RE: **18-DR-2020**  
Scottsdale Boutique Hotel  
**999V5 (Key Code)**

The Planning & Development Services Division has completed the review of the above referenced development application submitted on 1/13/2021. The following **1<sup>st</sup> Review Comments** represent the review performed by our team, and is intended to provide you with guidance for compliance with city codes, policies, and guidelines related to this application.

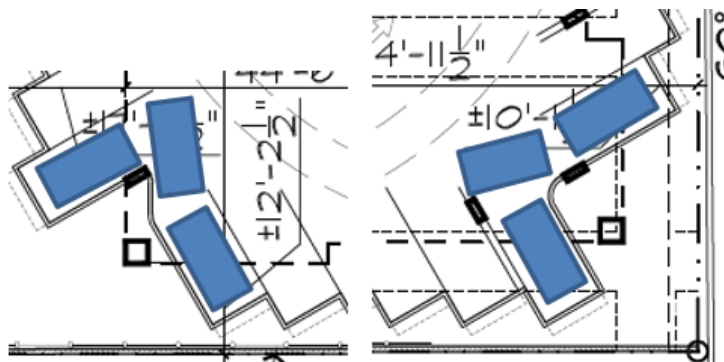
- 21. The Scottsdale Sensitive Design Principles as well as the Old Town Scottsdale Urban Design & Architectural Design Guidelines (Goal 18) promote the use of muted earth tones in applied treatments and paints on buildings. The proposed color palette includes colors that do not meet these guidelines. Please revise the building elevations and material board to meet the guidelines.
- 22. The Old Town Scottsdale Urban Design & Architectural Design Guidelines (Goal 18.7) promotes the use natural materials over simulated materials, particularly at the ground level of buildings. The proposed material palette includes materials that do not meet these guidelines. Please revise the building elevations and material board to meet the guidelines.
